PRODUCT UPDATE

PU-08-014

Product Update Hendrickson Lift Axle Control Kits

Lift Axle Control Kits

Current Lift Axle Assembly

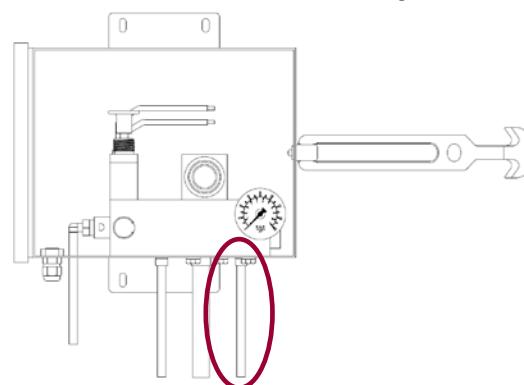
Hendrickson Trailer Commercial Vehicle Systems announces a change to its Lift Axle Control Kits. Beginning in late August 2018, the vent protector will be replaced with a ¼" NPTF barbed tube fitting and ¼" ID tube. This change is being made to commonize parts within the assembly. The barbed tube fitting and tube will be shipped loose and require installation.

The function of the Lift Axle Controls is unchanged. The part numbers affected are listed in the chart below. All kits, regardless of mounting option (bracket vs. stainless steel enclosure), will have this change. For illustration purposes, AKAD2011-1 is shown.

The vent protector aftermarket replacement part number, VS-31819, will no longer be available. It is replaced by VS-24580 barbed tube fitting and VS-24581 ¼" ID tube.
